Direct Drive Upblast Centrifugal Roof Exhaust Fan

Job No. 2023201.49

PROJECT
 9/10/2024
 CHIPOTLE-ROSENBERG, TX 5092
 MARK
 EF-2 (RESTROOM)

PROJECT: 9/10/2024 CHIPOTLE-ROSENBERG, TX 5092

EF-1 (Hood-1) : SELECTED OPTIONS AND ACCESSORIES

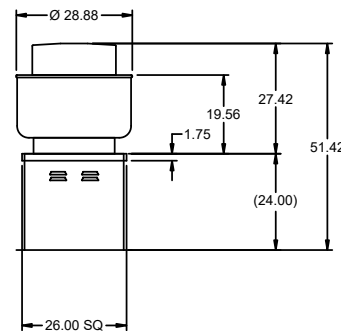
1. EF-1 should be three phase.
2. MAU-1 should be three phase and 208 volt.
3. Hood duct connections should be 28x6, and there should be three of them, not four.
